Subject: Duke Power Company LLC d/b/a Duke Energy
Carolinas, LLC (Duke)
Catawba Nuclear Station, Units 1 and 2
Docket Numbers 50-413 and 50-414
Request for Relief Number 06-CN-003
Use of Polyethylene Material in Nuclear Safety
Related Piping Applications

Response to NRC Requests for Additional Information (RAIs)

REQUEST FOR ADDITIONAL INFORMATION
REQUEST FOR RELIEF NO. 06-CN-003
DUKE POWER COMPANY, LLC
CATAWBA NUCLEAR STATION, UNITS 1 AND 2
DOCKET NOS 50-413 AND 50-414

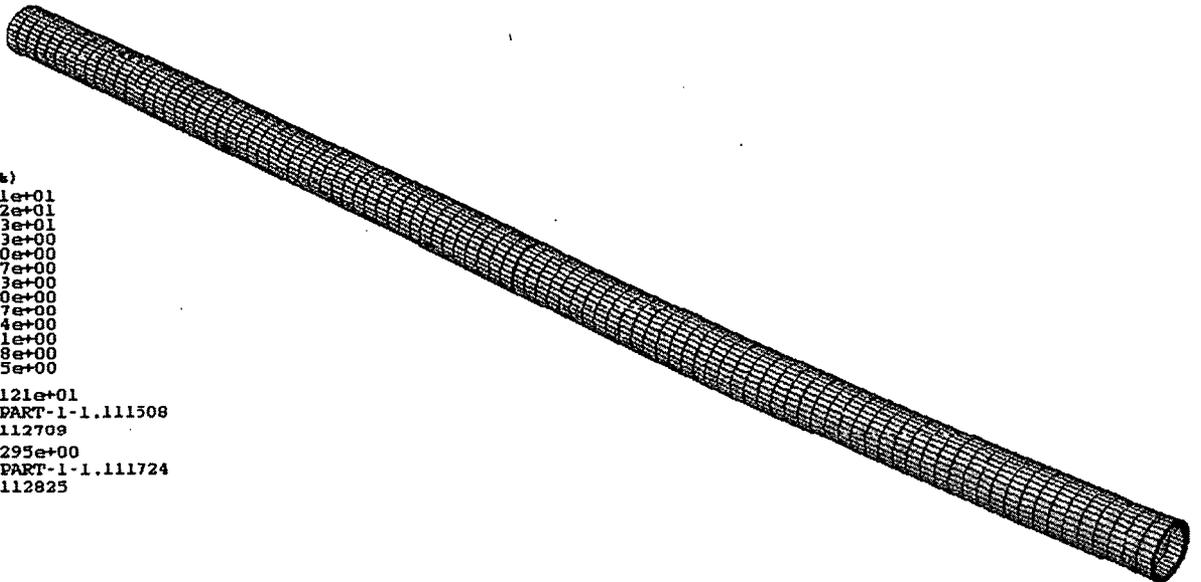
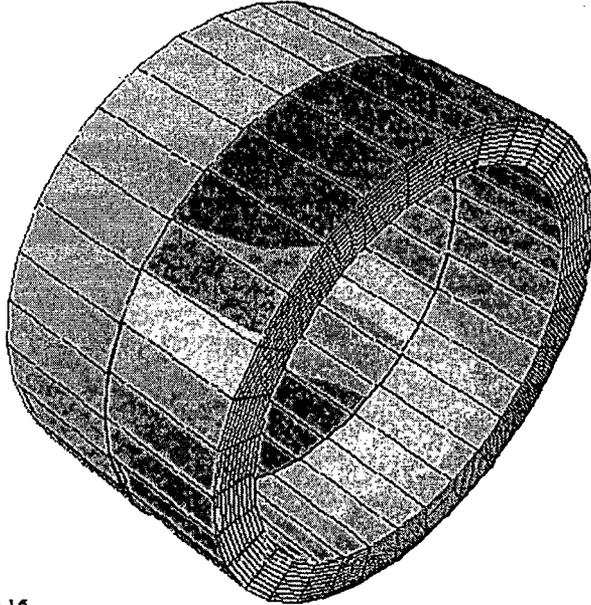
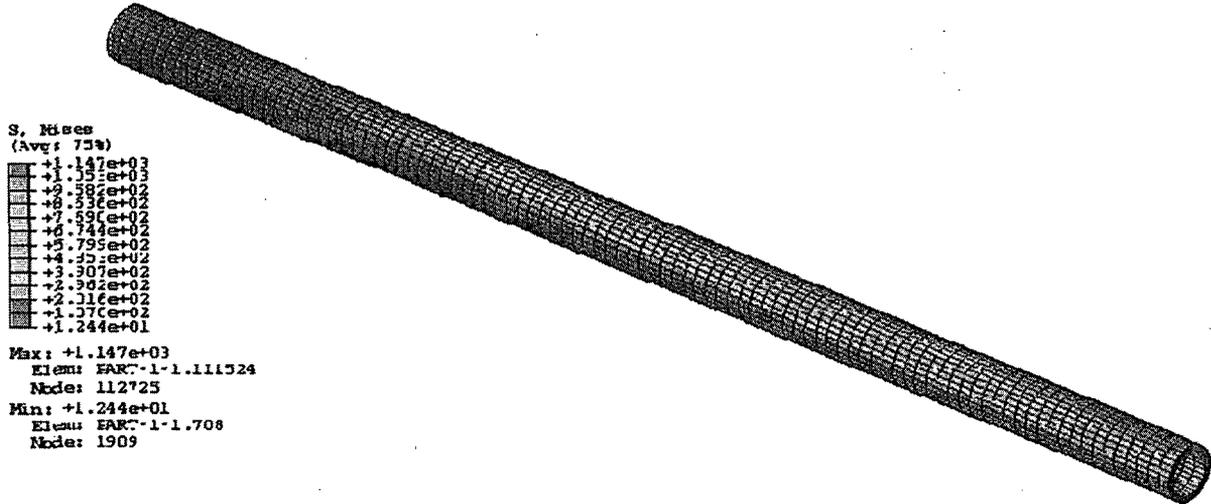
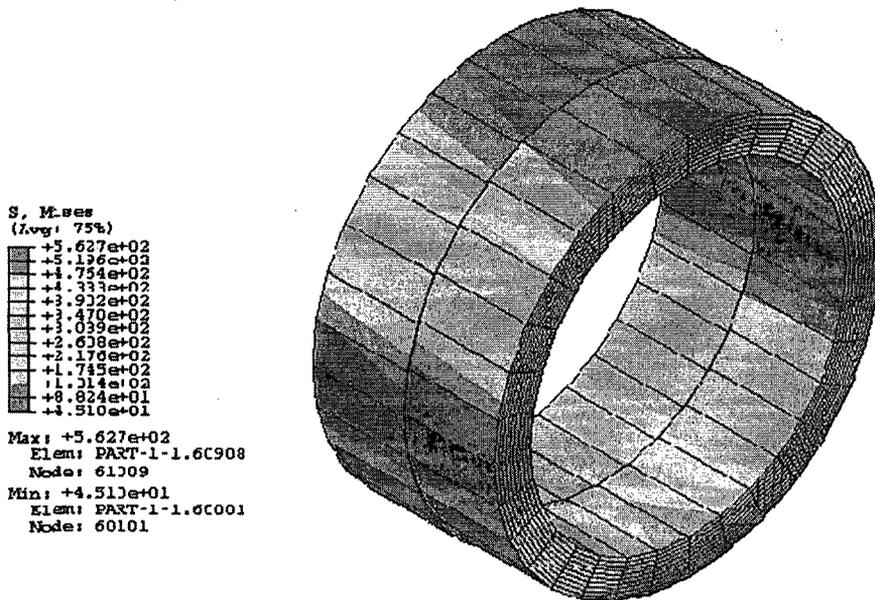
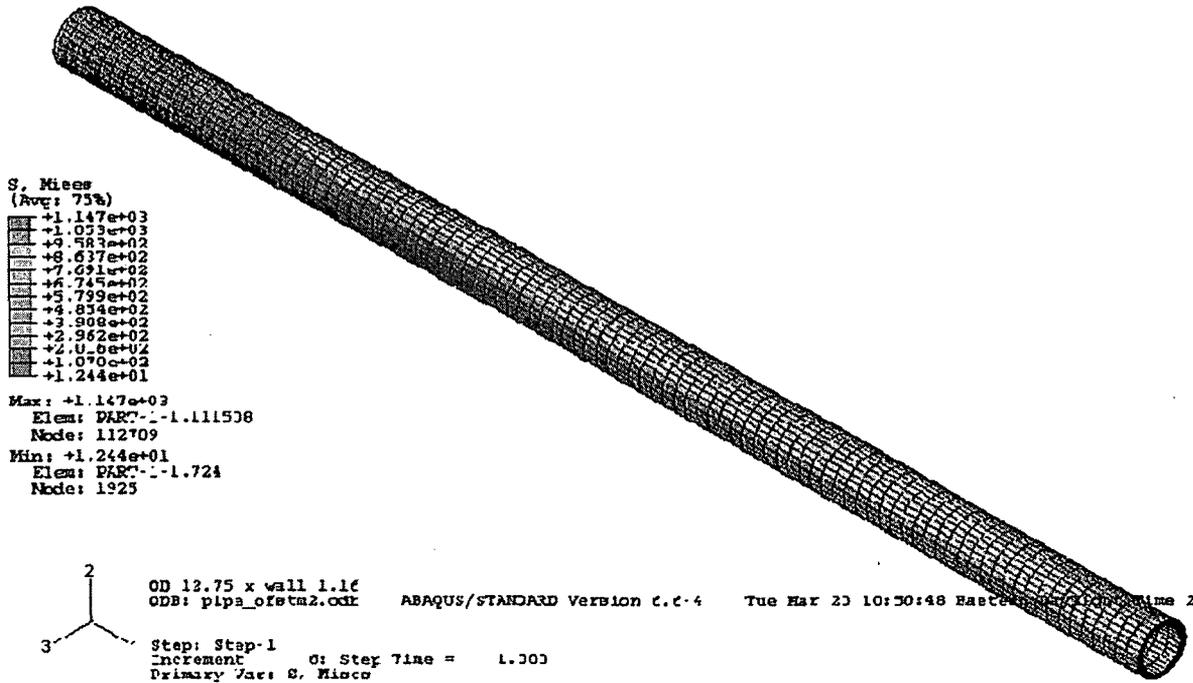
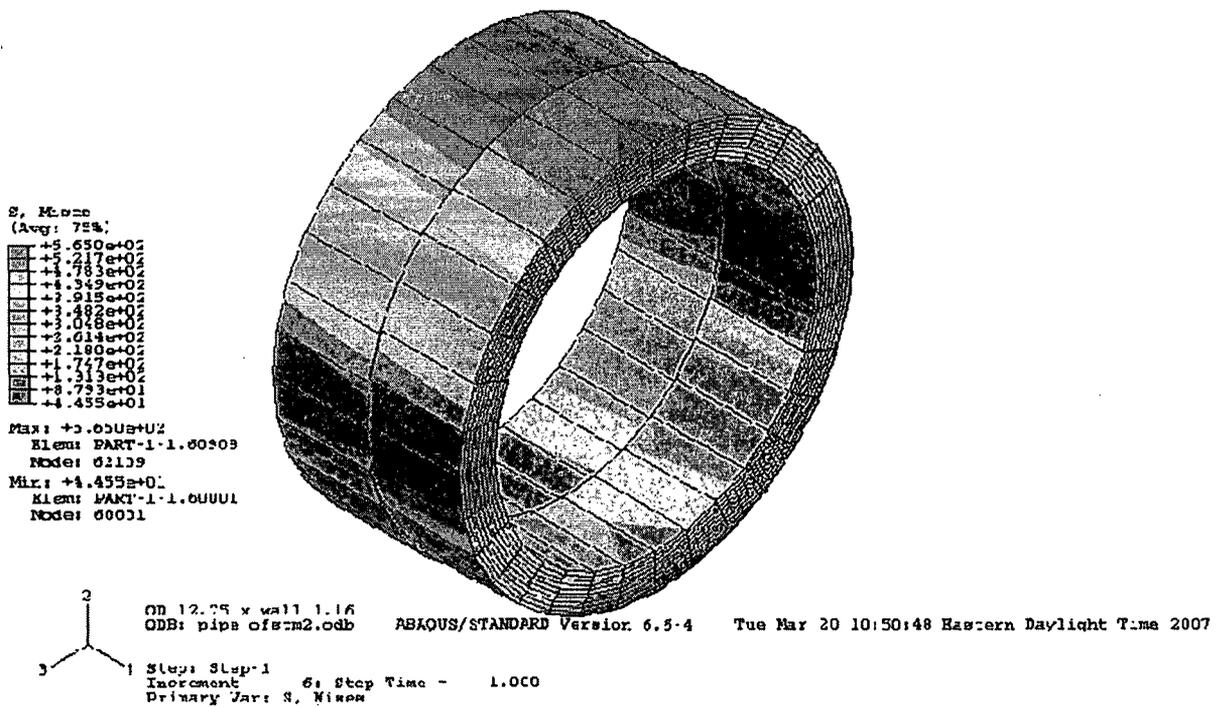
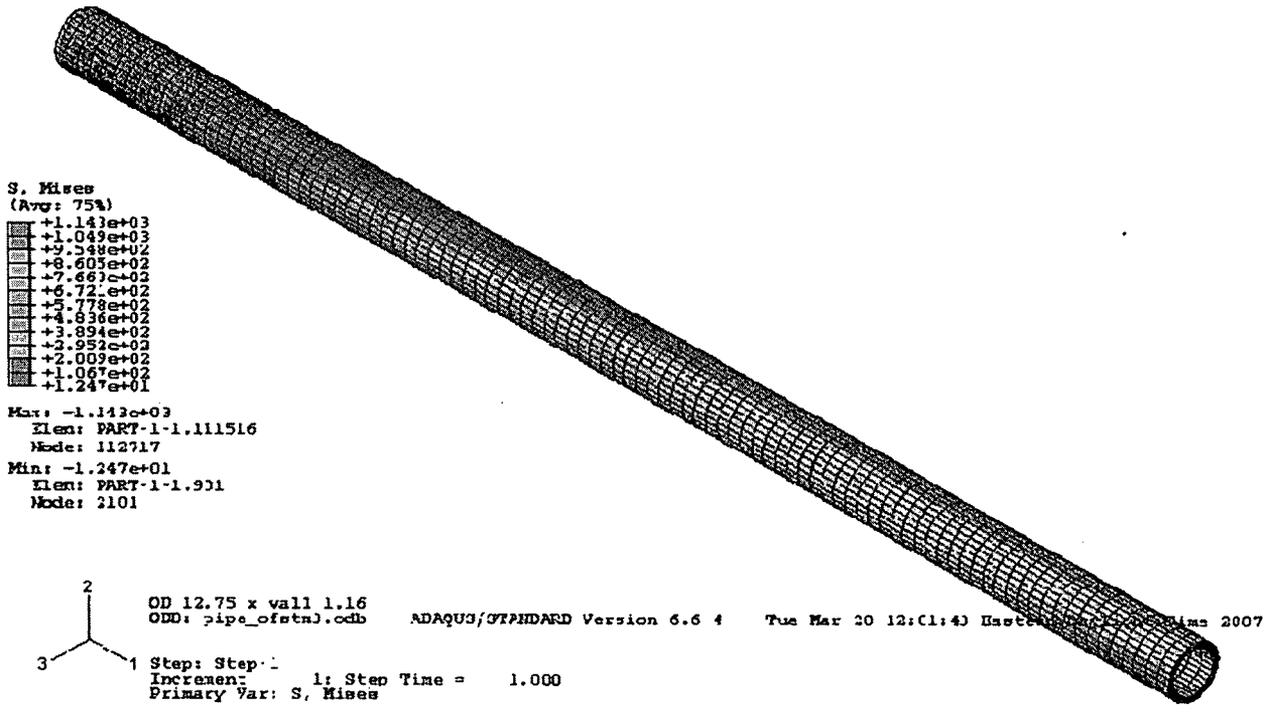
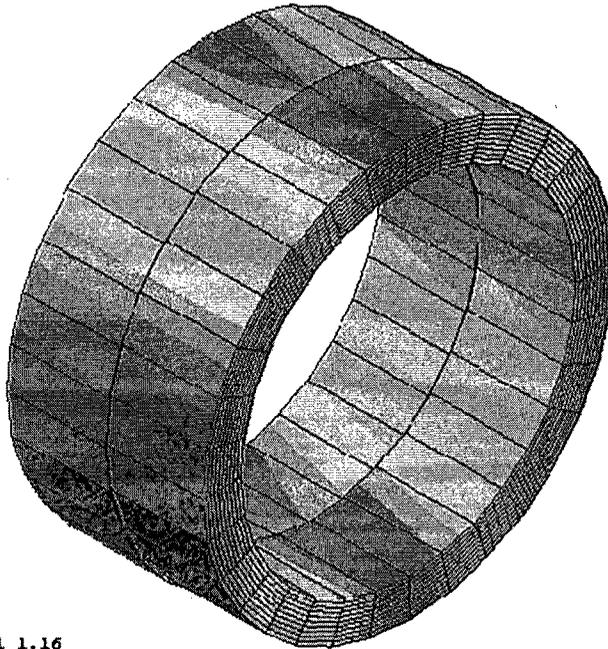
- (d) Is the justification for the offset or surface mismatch limit of 10% thickness (section 4421.2 of p. 24) based on G. Antacki's FEA results? To determine the peak stress effects at the abrupt step type change in the geometry due to the offset, it does not appear that the FEM mesh is reasonably fine enough locally. It seems like the FE mesh size is of the same size throughout the model. This needs confirmation using a finer mesh.

Duke Response (d):
